**DATE:** July 11, 2023  
**TO:** Blue Bird Owners  
**Subject:** R22CB: 7.3L Gas Supply Line And Shifter Cable Interference

**SUBJECT: R22CB: 7.3L Gas Supply Line And Shifter Cable Interference**

# RECALL R22CB

## 7.3L SHIFT CABLE-GASOLINE FUEL LINE INTERFERENCE

Fig 1

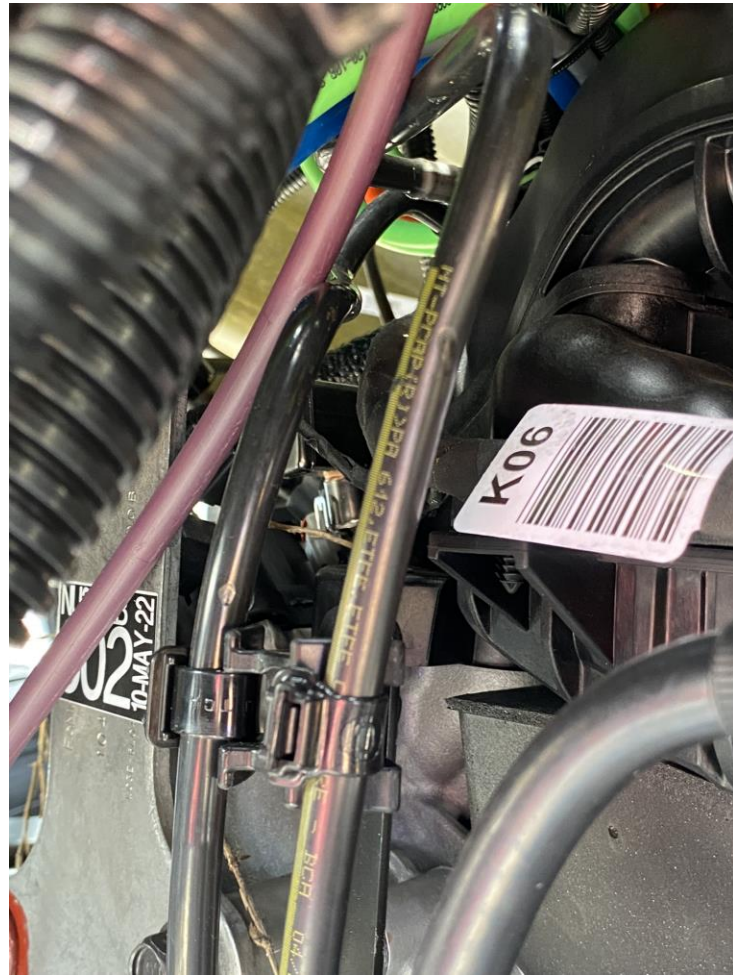
Step 1: Inspect the left rear corner of the engine from the top, and the bottom. If there is greater than 3” of clearance between the shift cable and the fuel line, no further action is required. Ref. Figure 1 for an example of insufficient clearance. If <3” of clearance, proceed to step 2.

Fig 2

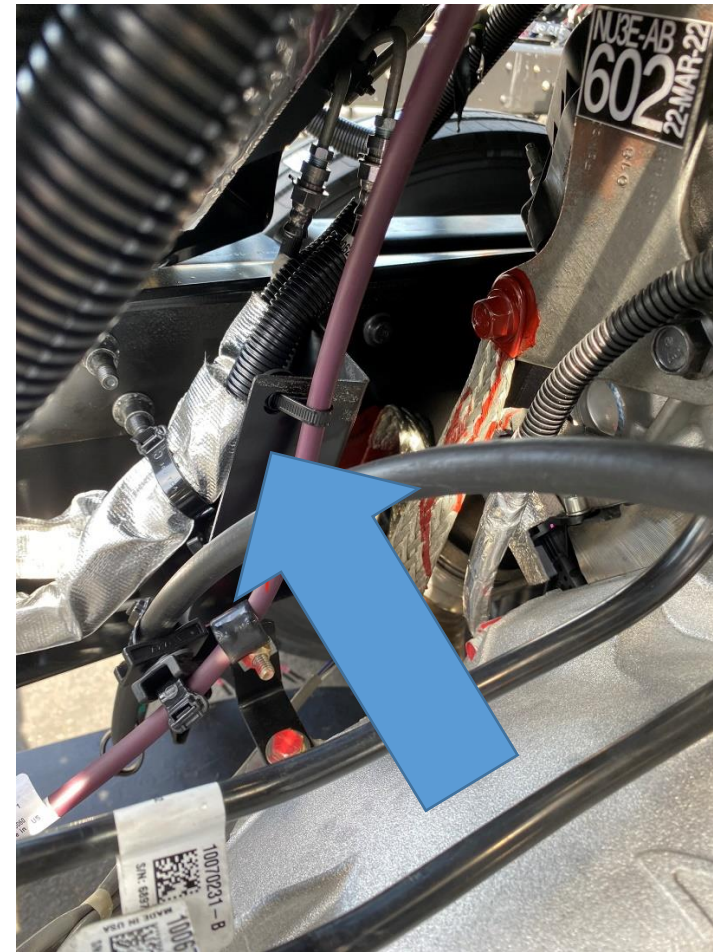
Step 3: Verify the heat shield bracket (Item 2), regardless of brake type is in place. Reference Figure 2. If missing, install per Figure 3.

Fig 3

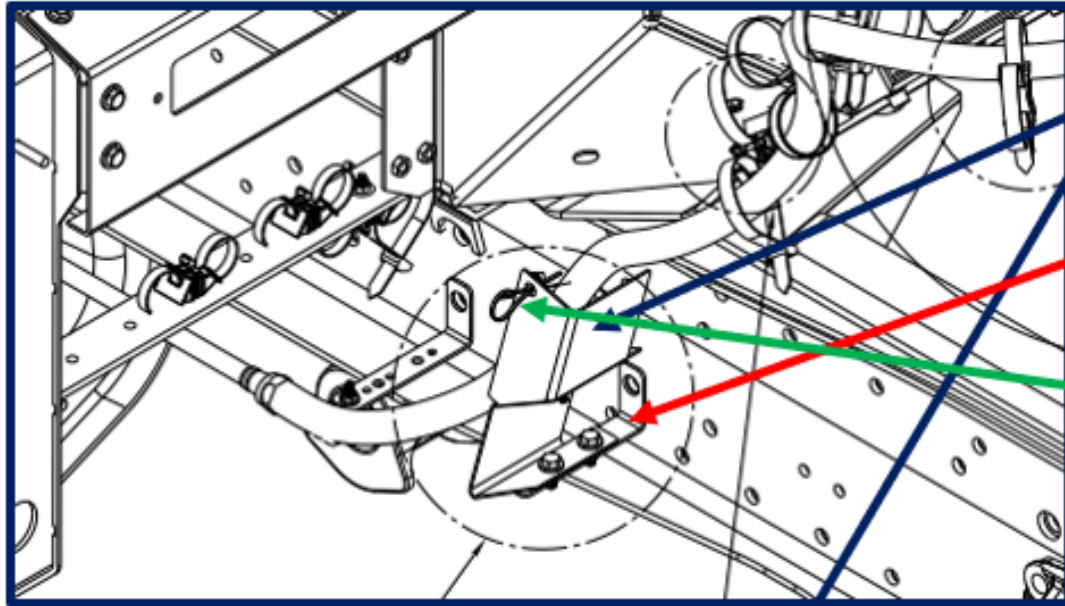
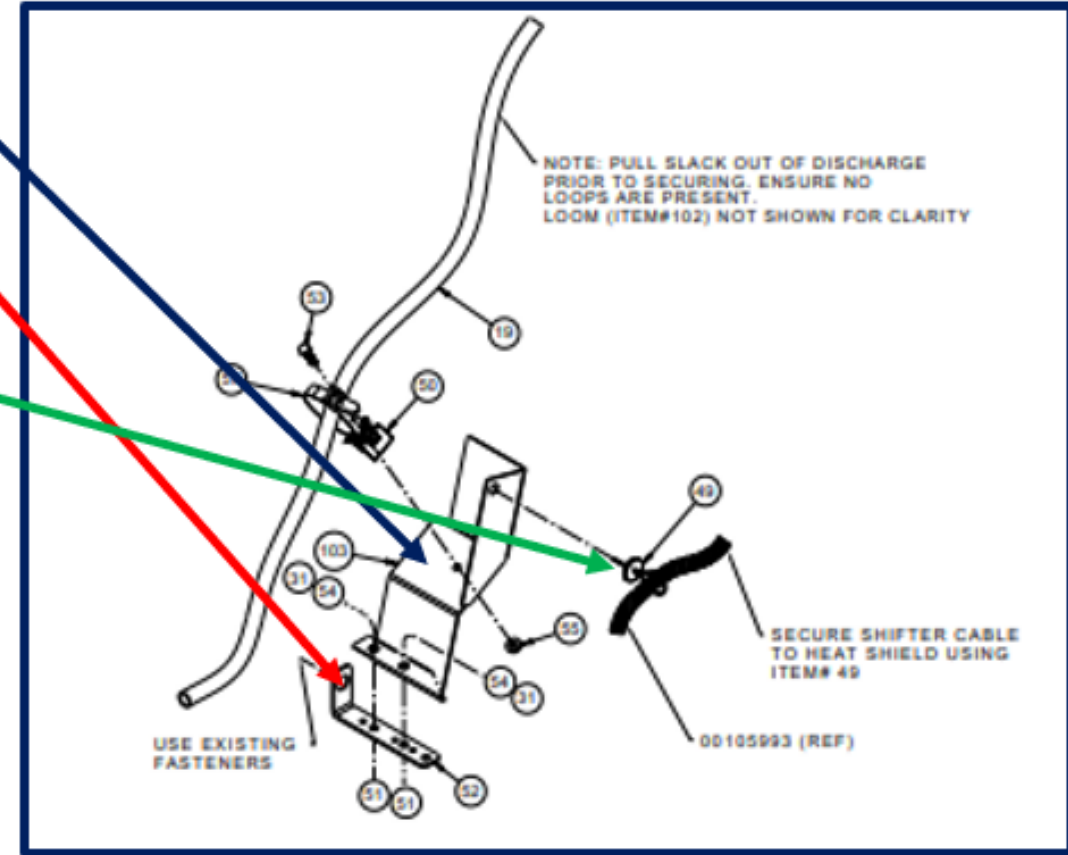
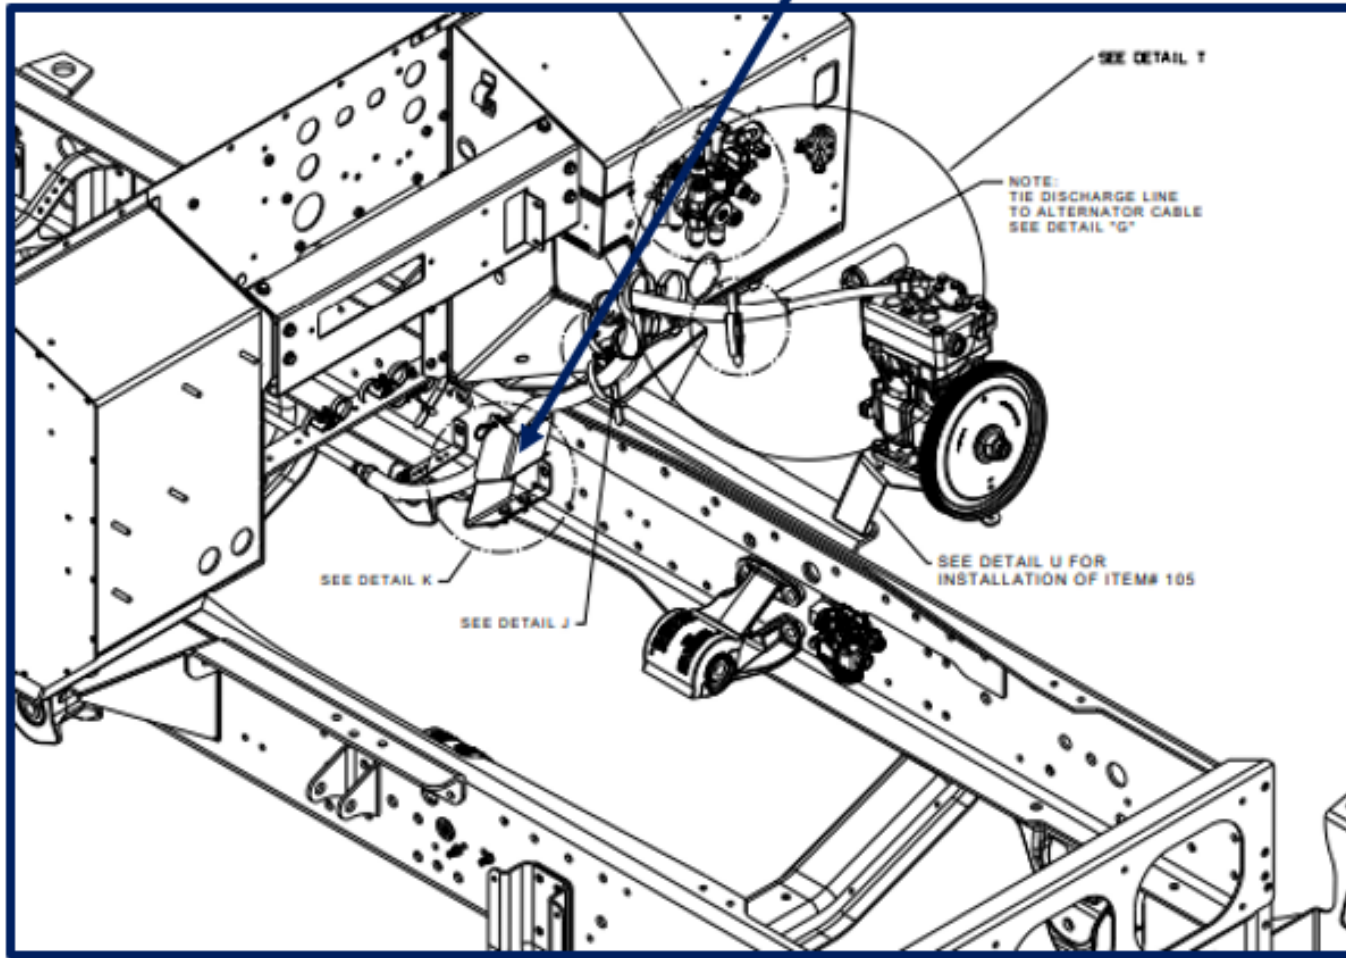
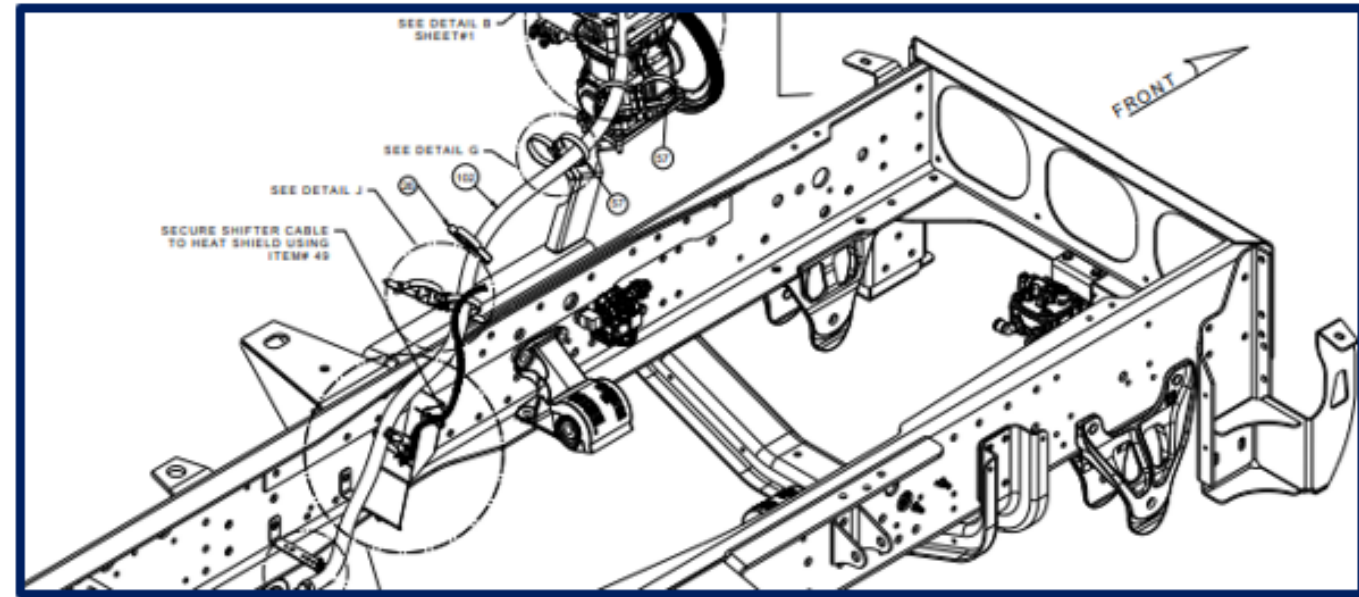
Step 4: Verify shift cable is routed properly and secured to the bracket with the HD button cable tie, p/n 00024076 per Figure 3

SECURE SHIFTER CABLE TO HEAT SHIELD USING ITEM# 49

SECURE SHIFTER CABLE TO HEAT SHIELD USING ITEM# 49

Fig 4

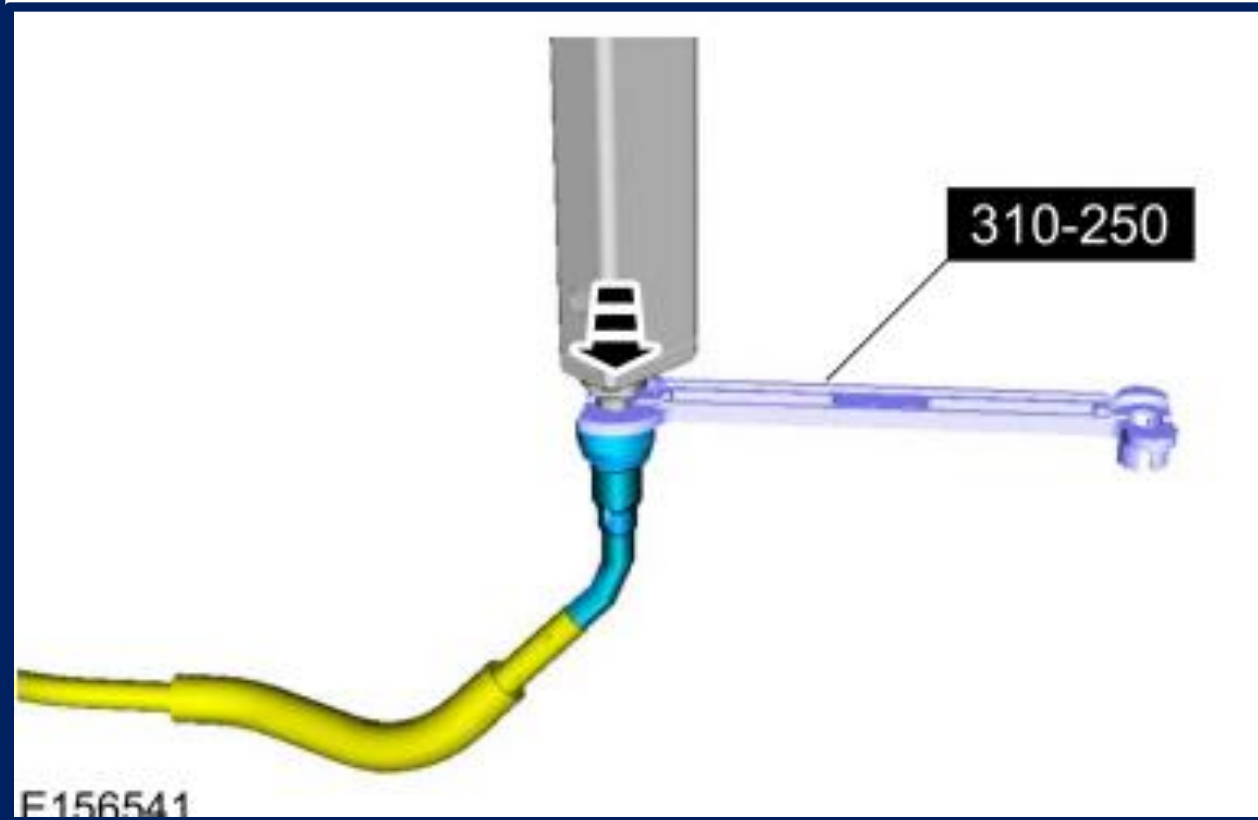
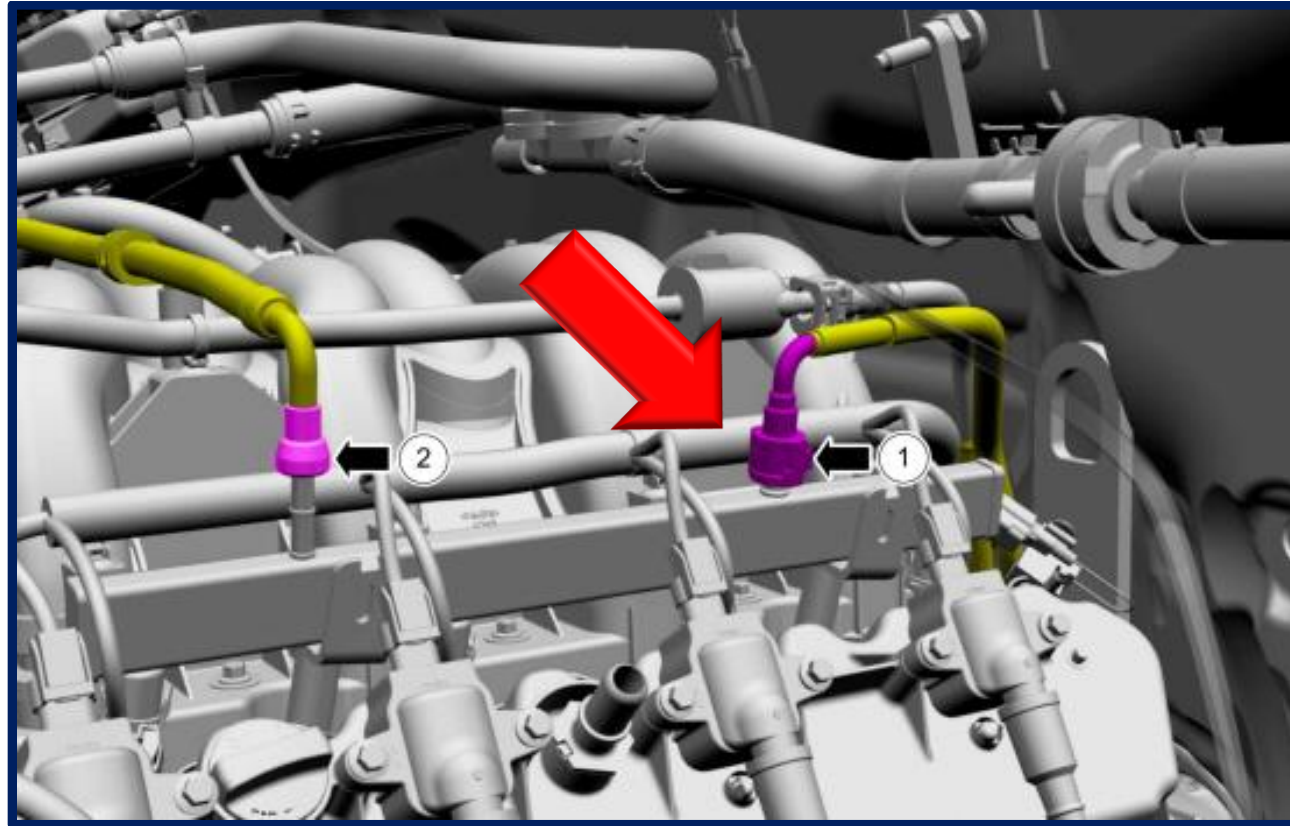
D- Wearing appropriate PPE, lay an absorbent cloth below the fuel line connection at the fuel rail and slowly disconnect the fuel line using Rotunda 310-250 or equivalent. See Figure 4
